Bradshaw and Mobley Compressor Sites

WEST VIRGINIA DEPARTMENT OF ENVIRONMENTAL PROTECTION WV OIL AND GAS CONSTRUCTION STORMWATER PERMIT

NOTICE OF VIOLATION

Violation No W18-52-021-RDD

Second site of sediment laden water leaving site at Bradshaw Compressor Station.

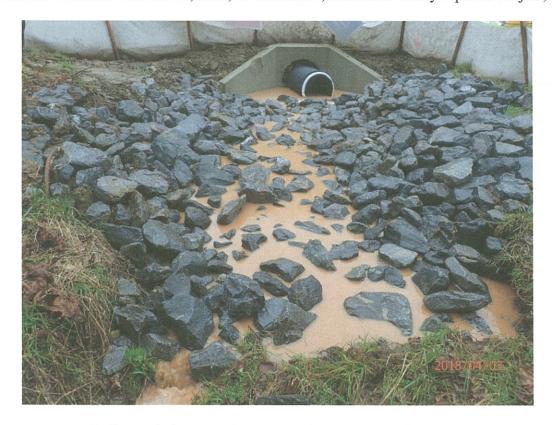
(1,6,14,19) There were three areas where sediment laden water was leaving the site under triple stack silt sock. Water not being properly channeled down the hill was eroding the hillside. Sediment has not impacted any waterbodies. Contractor has installed new perimeter controls below slip area. Water not being properly channeled down the hill creating rills and picking up sediment.

- Section G.4.e.2.A.ii.j Permittee has failed to prevent sediment-laden water from leaving the site without going through silt sock located at the Bradshaw Compressor Station.
- Section G.4.e.2. Permittee has failed to properly implement controls: lack of drop inlet protection at the Mobley Compressor Station.
- Section G.4.e.2.A.ii.f. Permittee has failed to protect fill slopes at the Bradshaw Compressor Station.

- Install properly operate and maintain silt sock to prevent sediment laden water from leaving the site.
- Provide proper inlet protection.
- Install erosion control devices to protect fill slopes.
